BECK NORTH UNITS 4 & 52 JSP20-12

Public hearing at the request of Dembs Development for Preliminary Site Plan, Woodland Permit and Storm Water Management Plan approval for a new 31,617 square foot speculative building for warehouse/office uses. The subject property is approximately 3.49 acres and is located in Section 4, north of West Road and west of Hudson Drive. The site is zoned I-1, Light Industrial District and is located in the Beck North Corporate Park.

Planning Review
Beck North Unit 4 & 52
 JSP 20-12

Review Date: July 21, 2020
Review Type: Preliminary Site Plan
Project Name: JSP 20-12 BECK NORTH UNITS 4 & 52
Location: 22-04-376-011 & 22-04-376-017; West of Hudson Dr, South of Cartier Dr
Plan Date: June 26, 2020
Prepared by: Lindsay Bell, Planner
E-mail: lbell@cityofnovi.org **Phone:** 248.347.0484

Figure 1. City of Novi Regulated Wetland & Woodland Map (approximate project parcel is shown in red). Regulated Woodland areas are shown in green and Regulated Wetland areas are shown in blue.

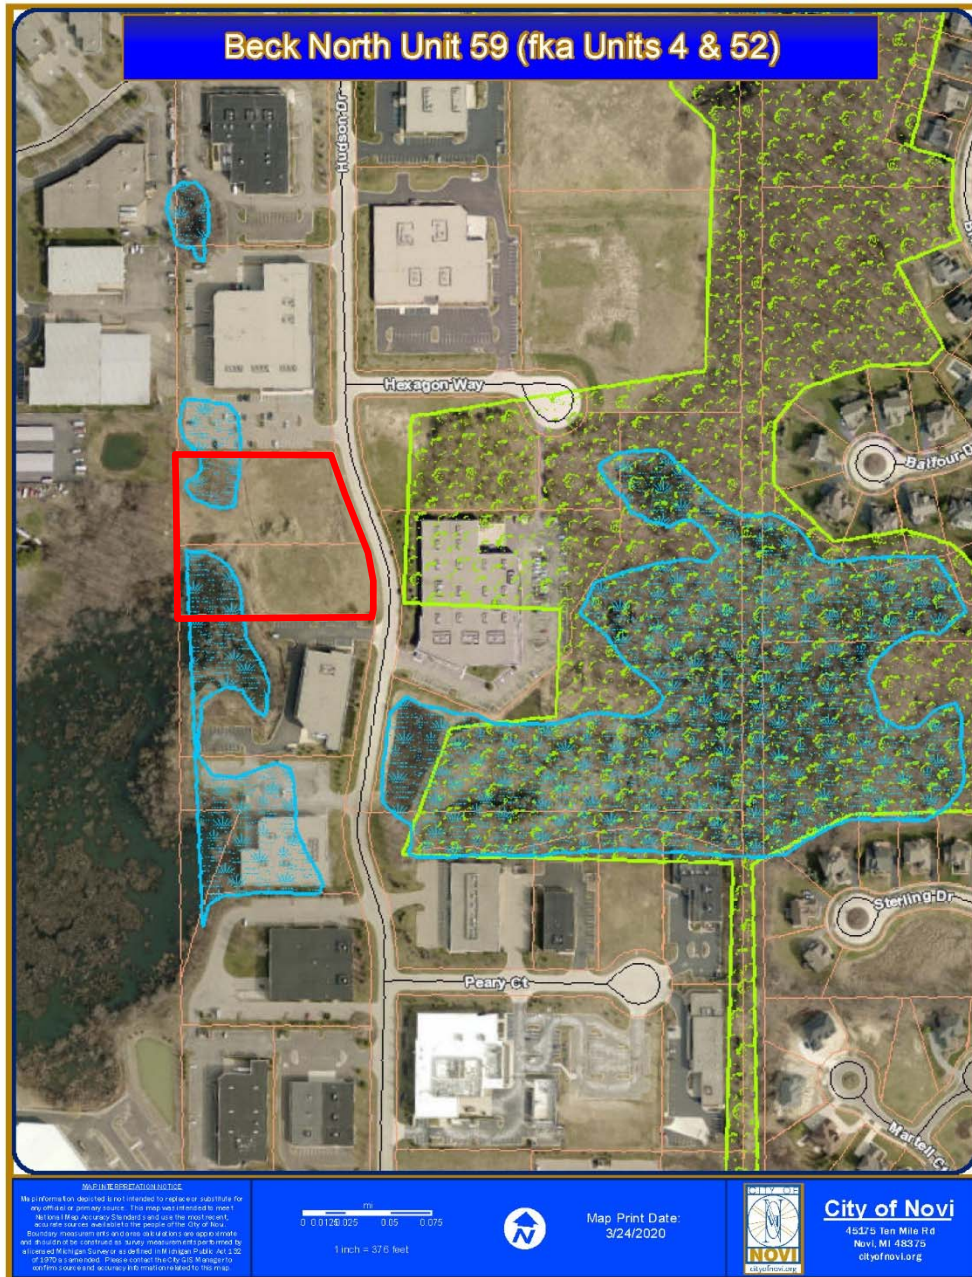
The southern parcel (fka Parcel 4) contains area designed as City-Regulated wetland in the southwest portion of the property (see Figure 1). The proposed limits of disturbance appear to avoid impact to this area of wetland. It should be noted that the current Plan indicates this existing area of wetland but does not include any specific wetland boundary data (such as wetland flag numbers from any previously completed wetland boundary delineations). The Plan also does not indicate a 25-foot wetland and/or watercourse setback boundary. The existing stormwater detention basin is located adjacent to (east of) the existing wetland area.

One (1) area of wetland is indicated on the Plan located in the southwest corner of Unit 4. The Topographic Survey (Sheet 3) indicates a Conservation Easement/Wetland Buffer line at the extents of this wetland area. It is suggested also that the applicant provide documentation/exhibits that identify the Conservation Easement Area as indicated on the Plan. As noted, no wetland flag number information or 25-foot wetland buffer boundary is indicated on the Plan. It should be noted however that the proposed limits of disturbance will remain outside of these areas.

Figure 1. City of Novi Regulated Wetland & Woodland Map (approximate project parcel is shown in red). Regulated Woodland areas are shown in green and Regulated Wetland areas are shown in blue.

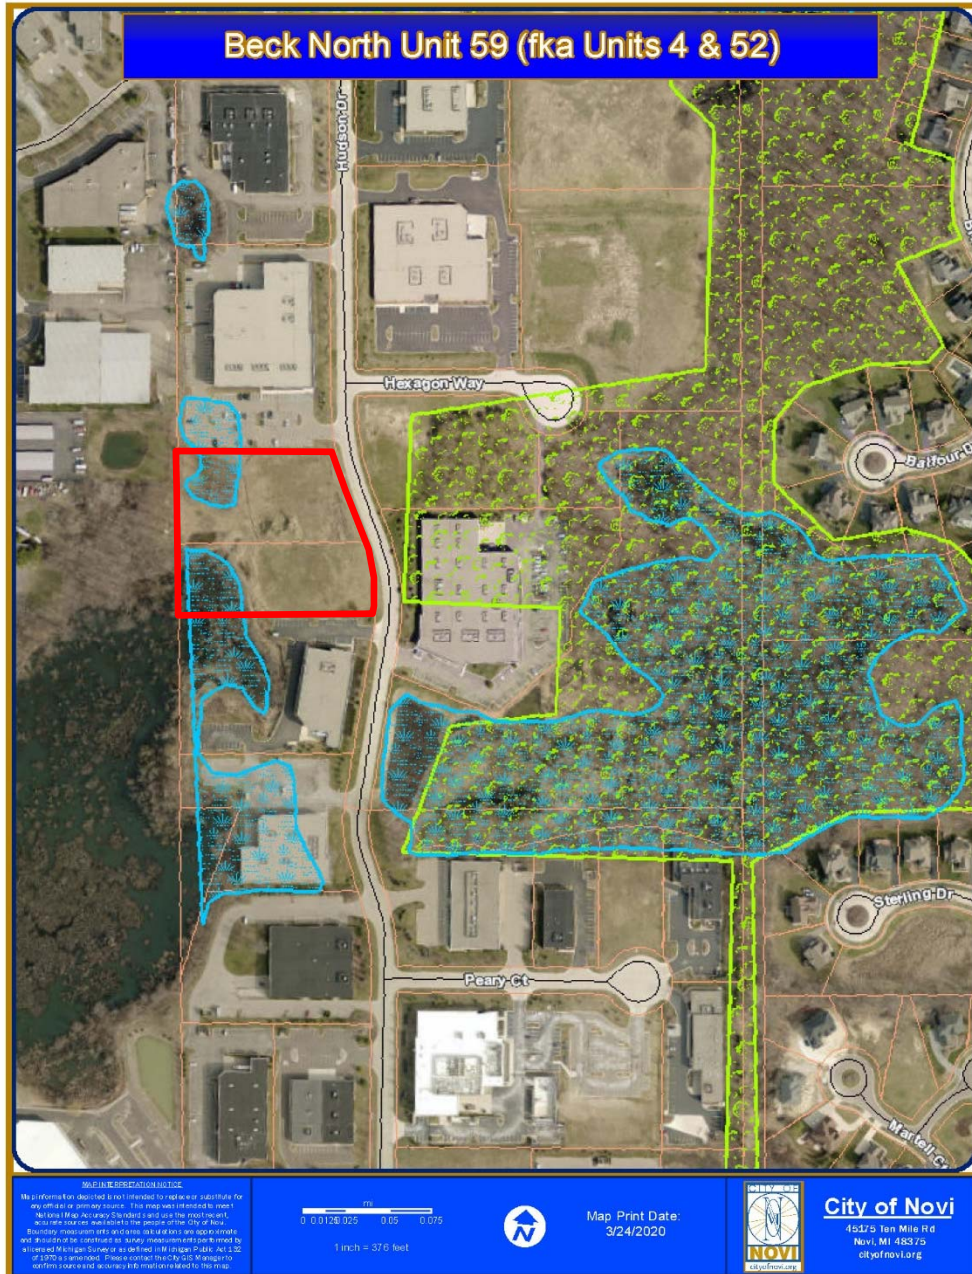
As noted above, this subject property does not contain areas currently mapped as City of Novi Regulated Woodland (see Figure 1) however, the northern parcel (fka Parcel 52) contains an area of existing woodland that was preserved from the original development of Beck North Corporate Park. This area of woodland was originally part of a larger contiguous woodland and is still considered regulated by the City of Novi. The current Plan includes a survey of existing trees and a tree list that indicates tree tag number, diameter, tree type, condition, removal status and Woodland Replacements required.

ECT's in-office review of available materials included the City of Novi Regulated Woodlands map, USGS topographic quadrangle map, NRCS soils map, and historical aerial photographs. As noted above, areas noted as City-Regulated Wetland are located in the southwestern portion of the subject property. Although not mapped, it is ECT's assessment that an area containing trees that are considered City-Regulated Woodland is located in the northwestern portion of the subject property (see Figure 1). It can also be noted that the area of Regulated Wetlands located in the southwest portion of the site also contains Regulated Woodland.
